RE Parcel Map No. AA-2015-0777-PMLA-SL
Address: 1324 Quintero Street
Planning Area: Silver Lake – Echo Park –
Elysian Valley
Zone : RD1.5-1VL
C. D. : 13 – Mitch O'Farrell
CEQA : ENV-2015-0778-MND

LETTER OF CLARIFICATION

RE: Parcel Map No. AA-2015-777-PMLA
Address: 1324 Quintero Street
Related Case: N/A
Planning Area: Silver Lake – Echo Park –
Elysian Valley
Zone : RD1.5-1VL
D. M. : 139-5A211
C. D. : 13
CEQA : ENV-2015-778-MND

REVISED PRELIMINARY PARCEL MAP NO. AA FOR SMALL LOT SUBDIVISION PURPOSES LEGAL DESCRIPTION

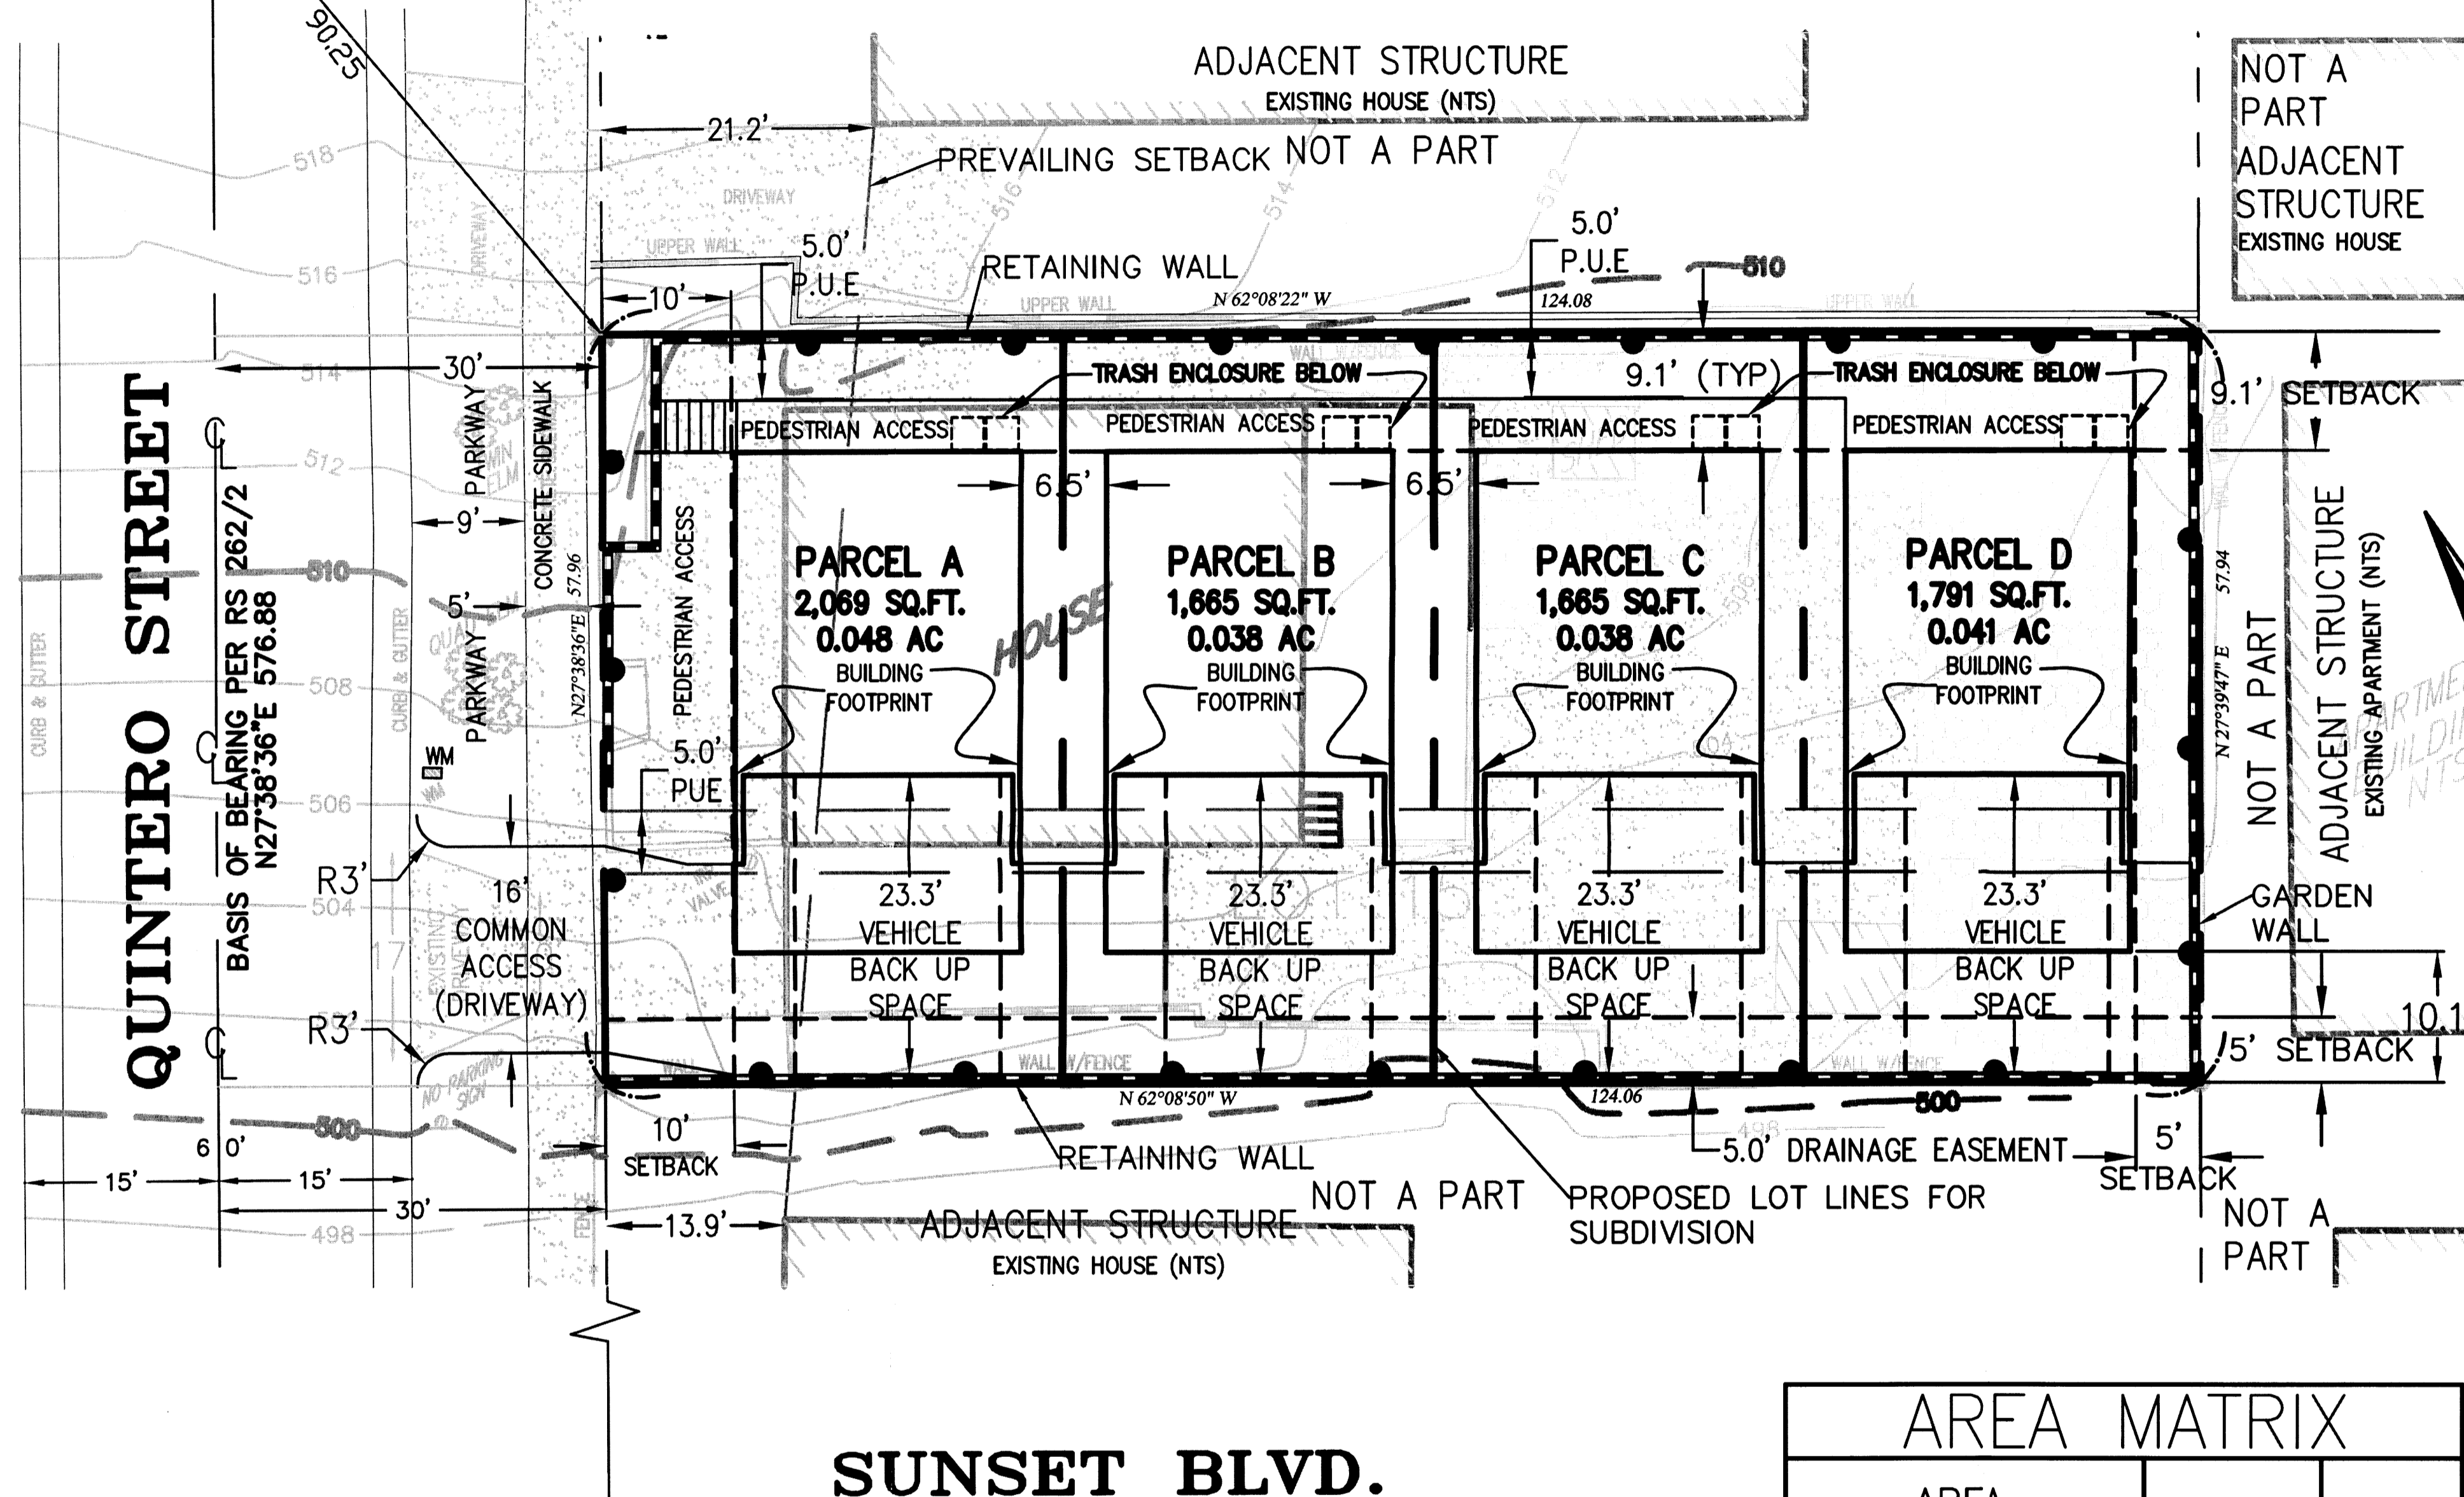
- c. The Map does not comply with the minimum 15 ft. front yard setback for Parcel 1 fronting (facing) along Quintero Street as required for the **RD1.5-1VL Zone**. Revise the Map to show compliance with the above requirement

or obtain written approval from the Department of City Planning Advisory Agency to allow the reduced setback as indicated in the Setback Matrix.

- d. Resubmit the map to provide and maintain a minimum 20 ft. common access strip open to the sky all the way to the public street for frontage and driveway access purposes for Parcels 2, 3, and 4. No projection is allowed in the required common access strip. Revise the Map to show compliance with the above requirement or obtain approval from the Department of City Planning to allow any projection into the required 20 ft. minimum wide access strip all the public street.

Setbacks				
Parcel	Front (W)	Side (N)	Side (S)	Rear (E)
A	10'-0"	9'-1"	10'-1"	3'-3"
B	3'-3"	9'-1"	10'-1"	3'-3"
C	3'-3"	9'-1"	10'-1"	3'-3"
D	3'-3"	9'-1"	10'-1"	5'-0"
